# CITY COUNCIL MEETING CENTRAL MILLING SITE PLAN- FLOUR MILL 168 SOUTH 1720 EAST NOVEMBER 5, 2015

Central Milling-Hyrum SITE

C-100

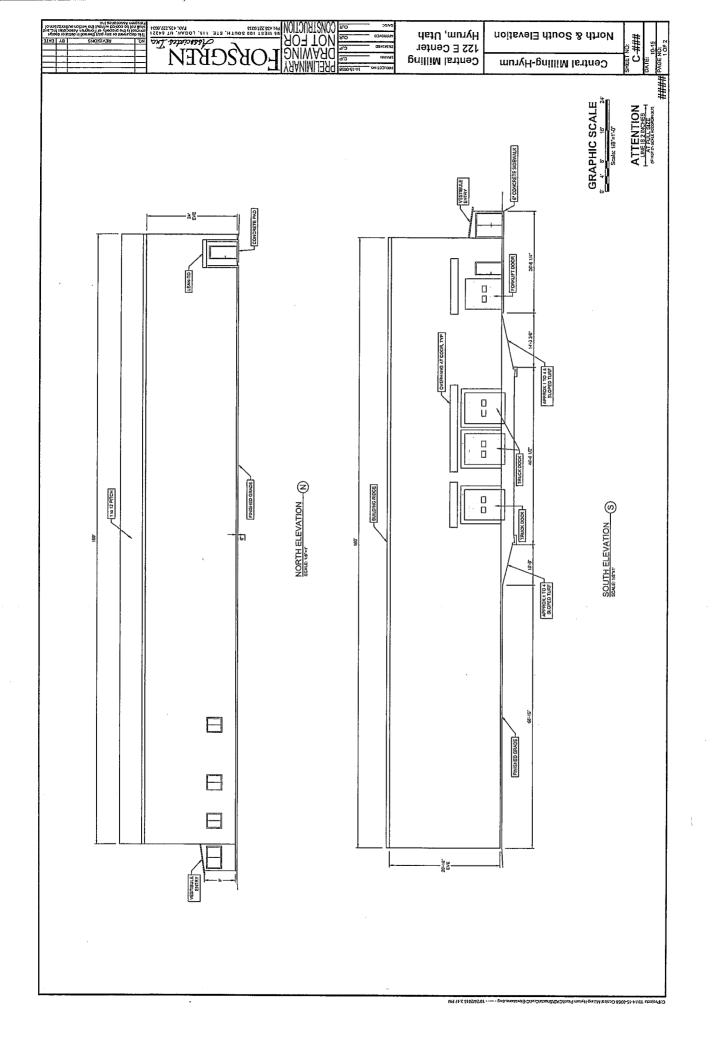
FENCING- None proposed with this phase. They own the whole park and plan to expand as needed.

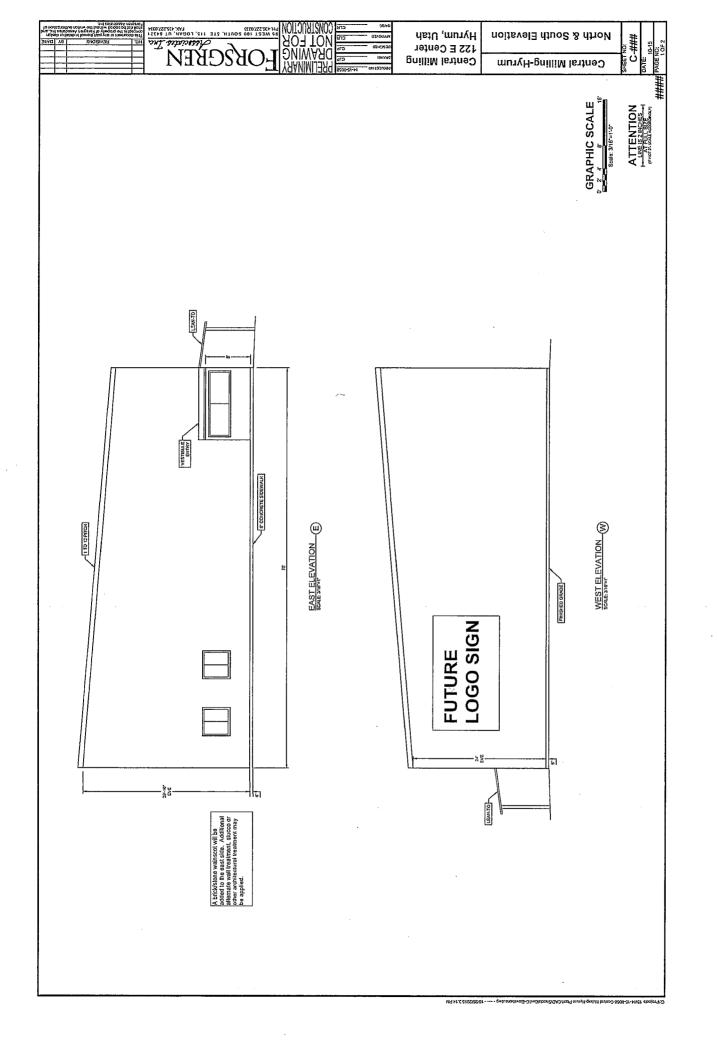
LANDSCAPPING- They are proposing grass around the building. They have agreed to add some trees to the site.

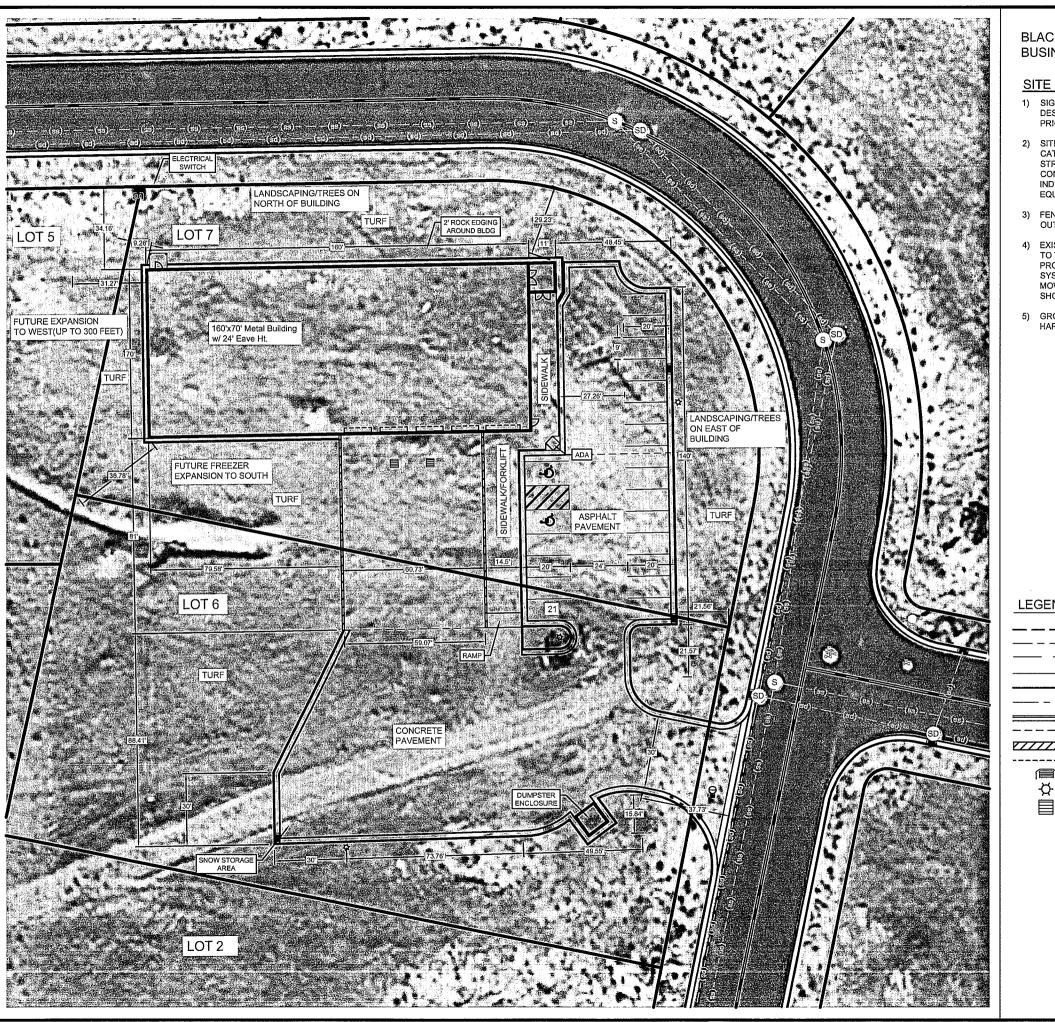
LIGHTING- As shown. There is also existing street lighting.
